ADDENDUM
NO. 4

Loy Norrix High School Mechanical Improvements
606 East Kilgore Rd
Kalamazoo, MI 49001

ADDENDUM NO. 2

| ARCHITECT'S PROJECT NO.: | 21-807.00 |

LOWER LEVEL FLOOR PLAN - UNIT K
3/32" = 1'-0"

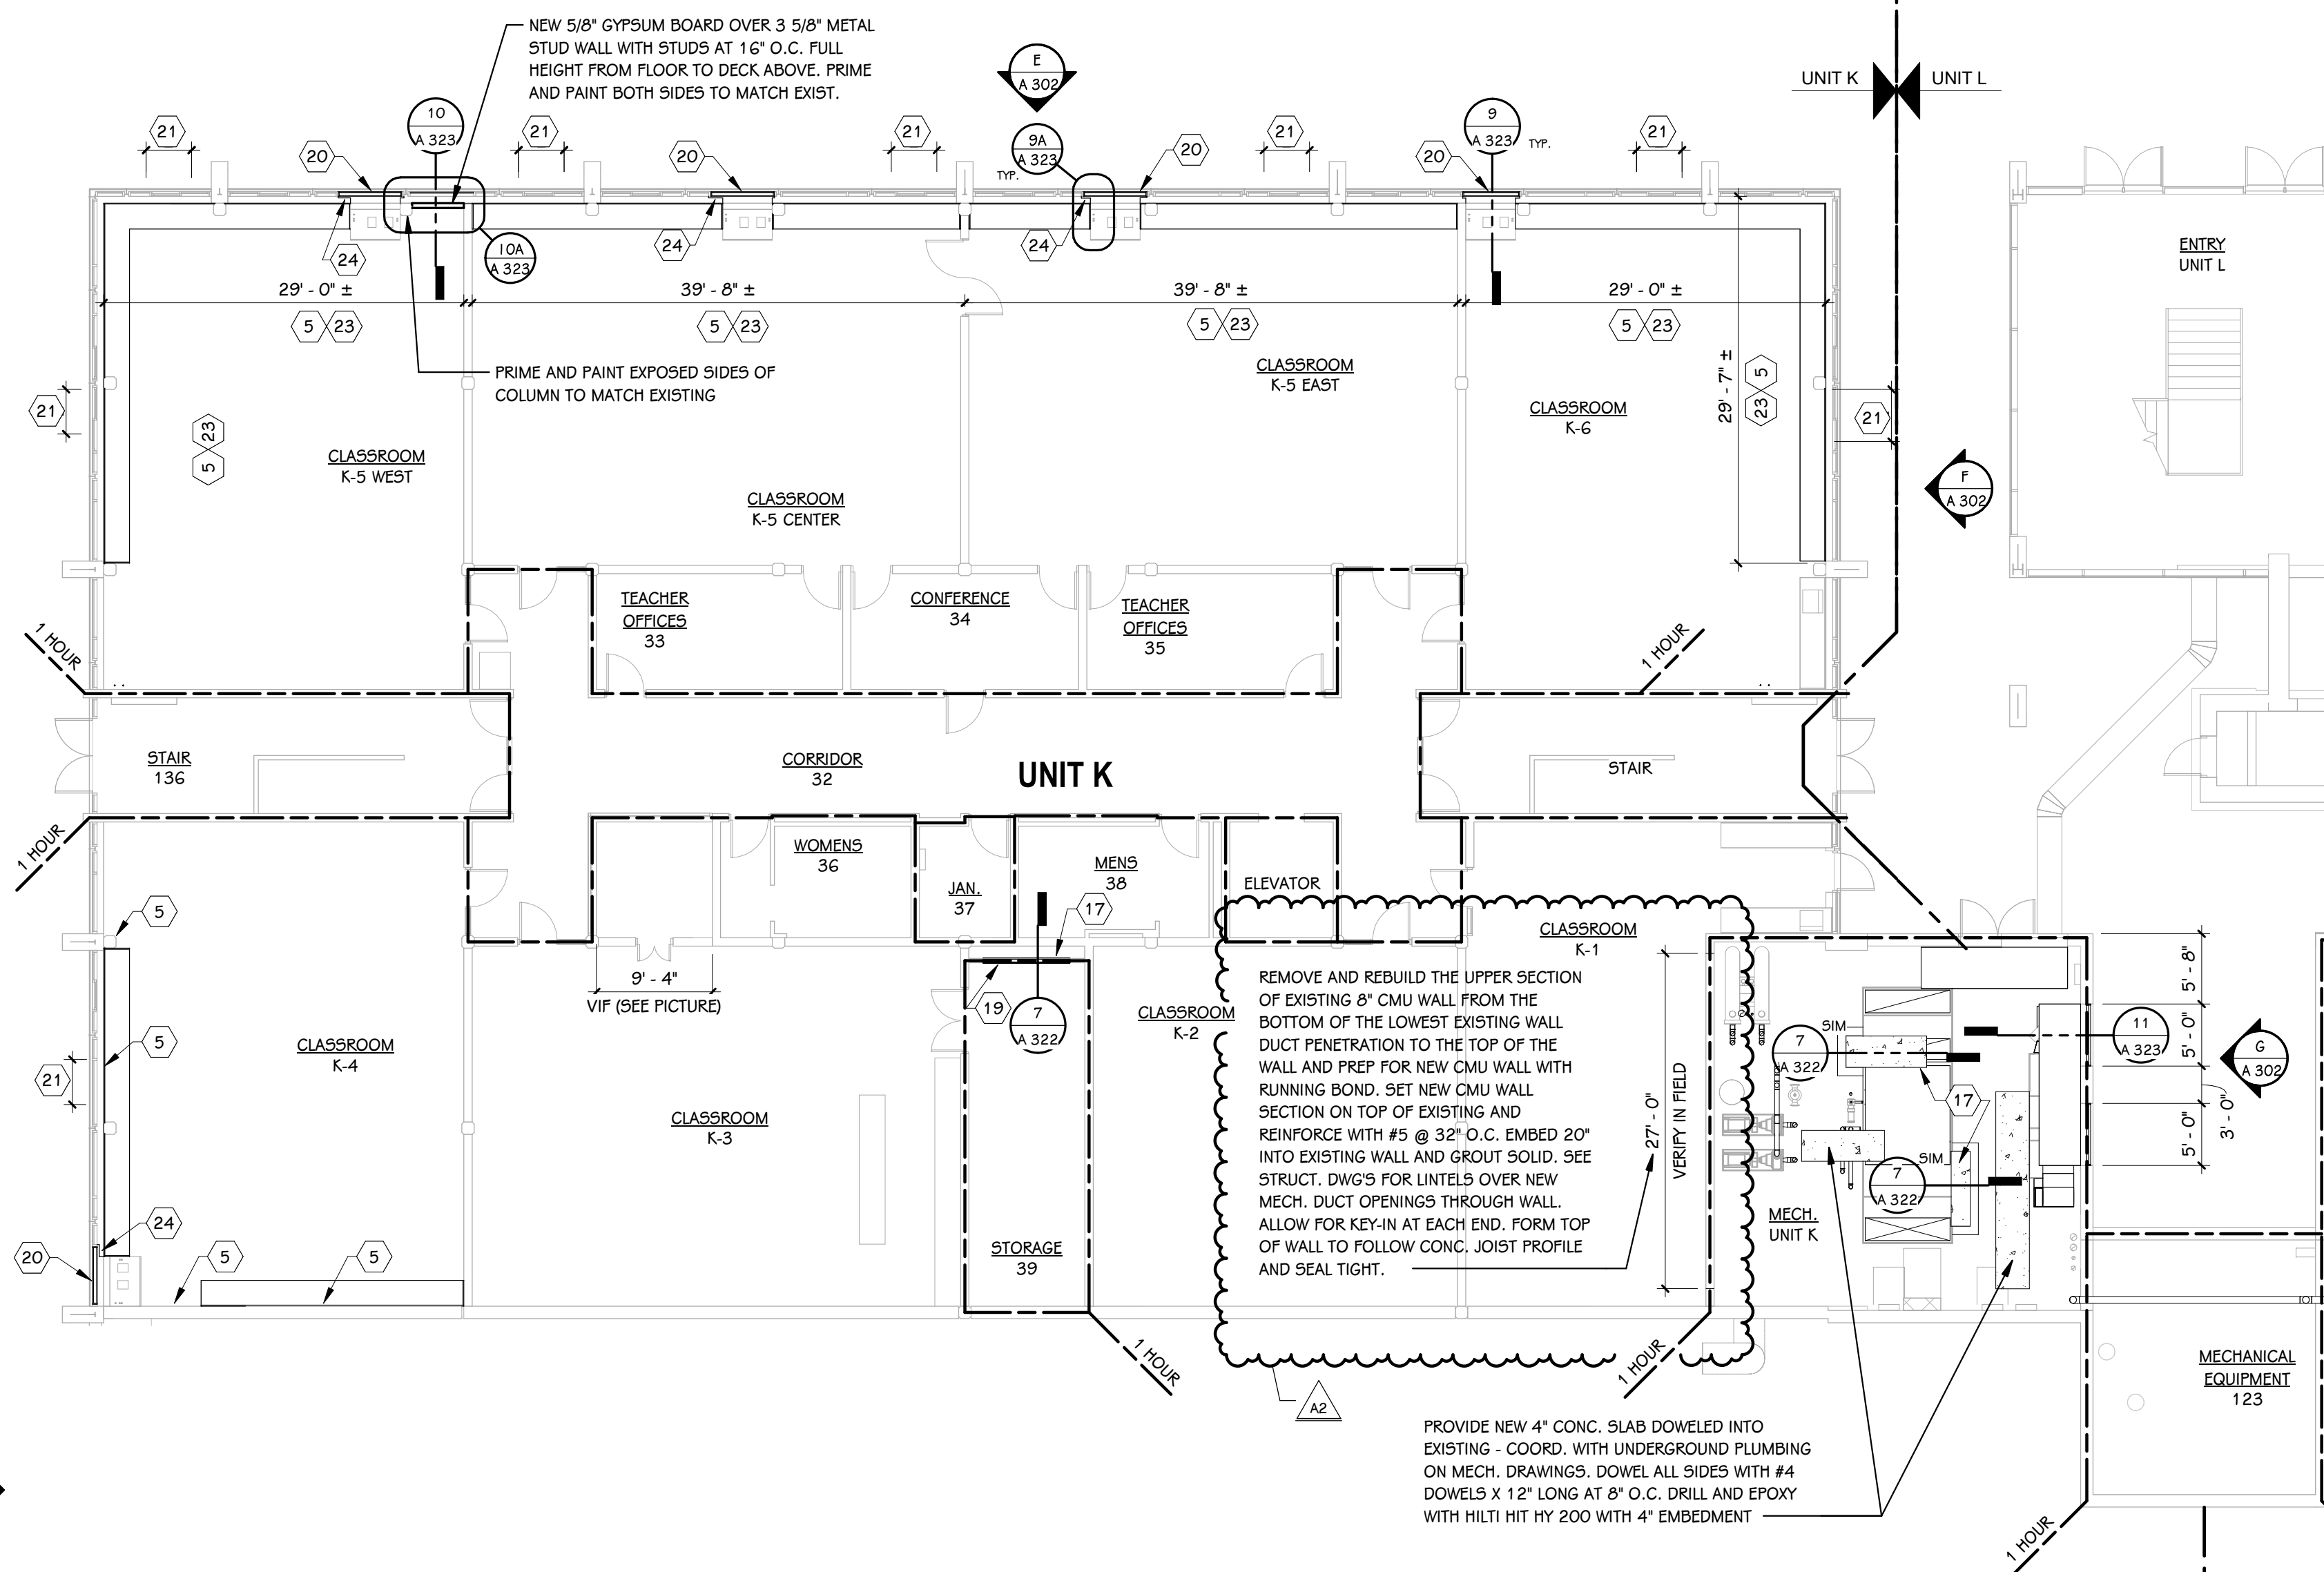
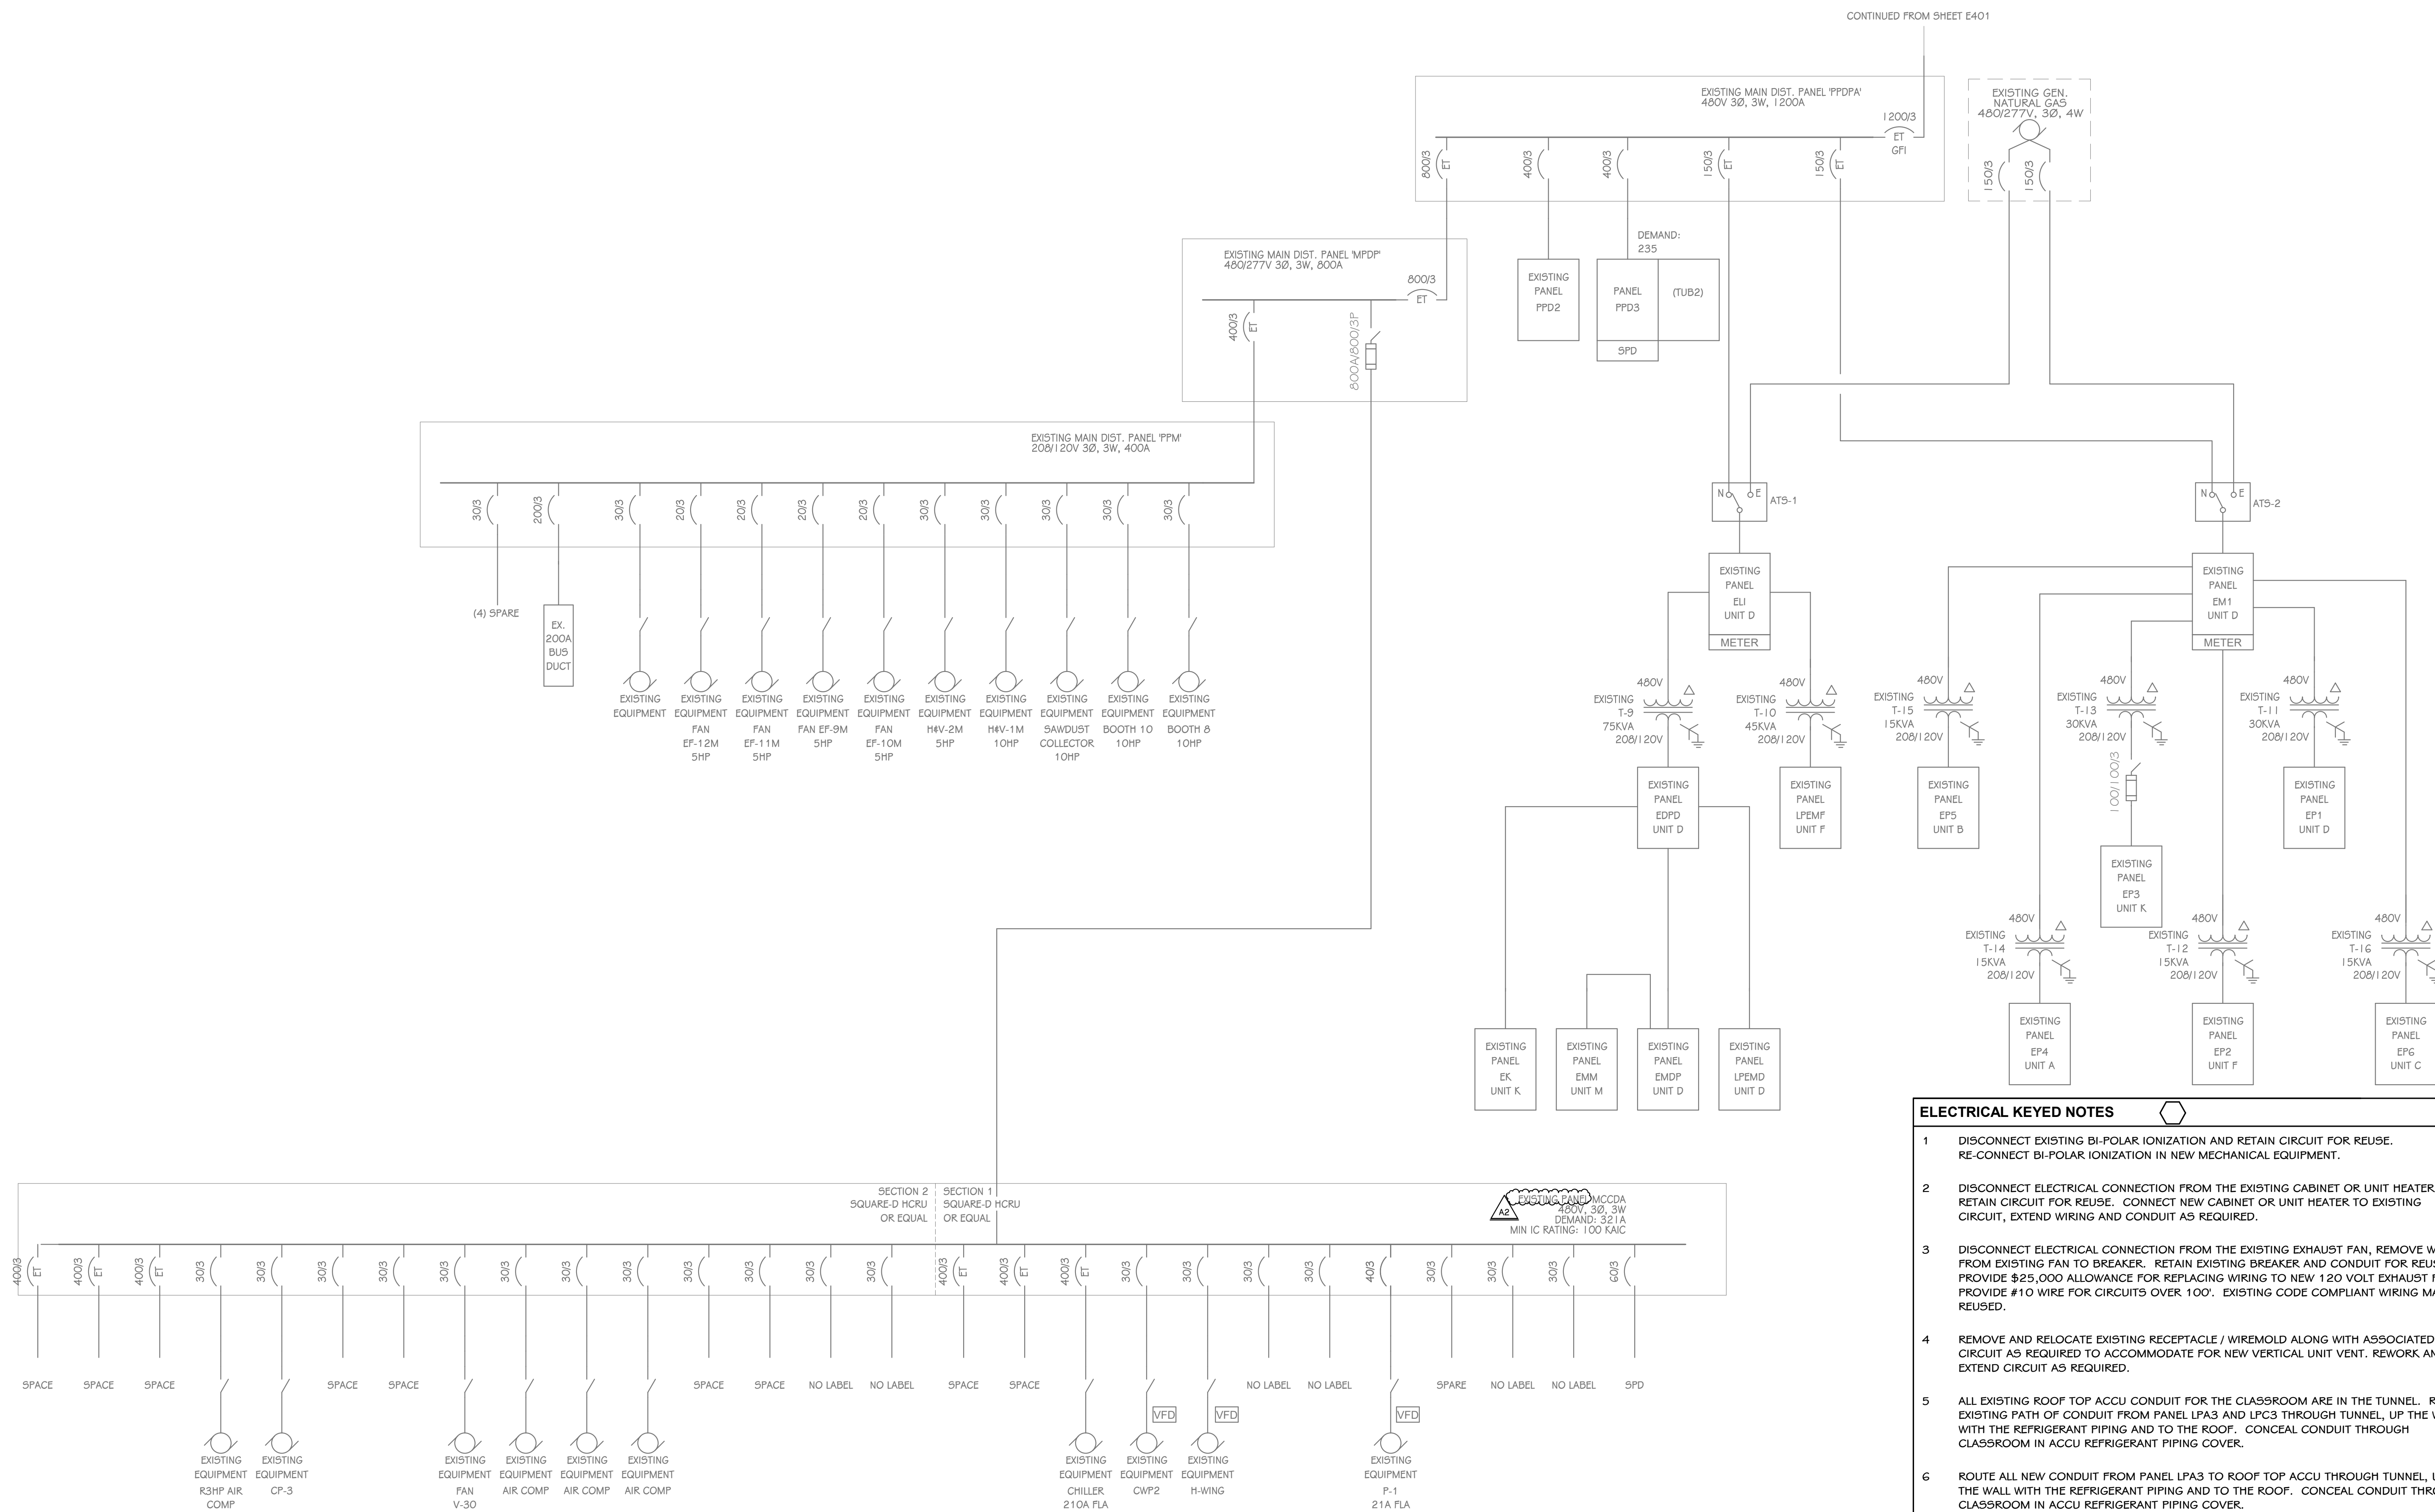
ADD-2 Item No. D-2 - Classroom K-1 Wall

Refer to Reissued Sheet[s]: A 100K

Remove and rebuild the upper section of the wall between Classroom K-1 and Mech. Room from the bottom of the lowest existing wall duct penetration to the top of wall. See Drawing A 100K for more details.

REMOVE AND REBUILD THE UPPER SECTION OF EXISTING 8" CMU WALL FROM THE BOTTOM OF THE LOWEST EXISTING WALL DUCT PENETRATION TO THE TOP OF THE WALL AND PREP FOR NEW CMU WALL WITH RUNNING BOND. SET NEW CMU WALL SECTION ON TOP OF EXISTING AND REINFORCE WITH #5 @ 32" O.C. EMBED 20" INTO EXISTING WALL AND GROUT SOLID. SEE STRUCT. DWGS FOR LINTELS OVER NEW MECH. DUCT OPENINGS THROUGH WALL. ALLOW FOR KEY-IN AT EACH END. FORM TOP OF WALL TO FOLLOW CONC. JOIST PROFILE AND SEAL TIGHT.
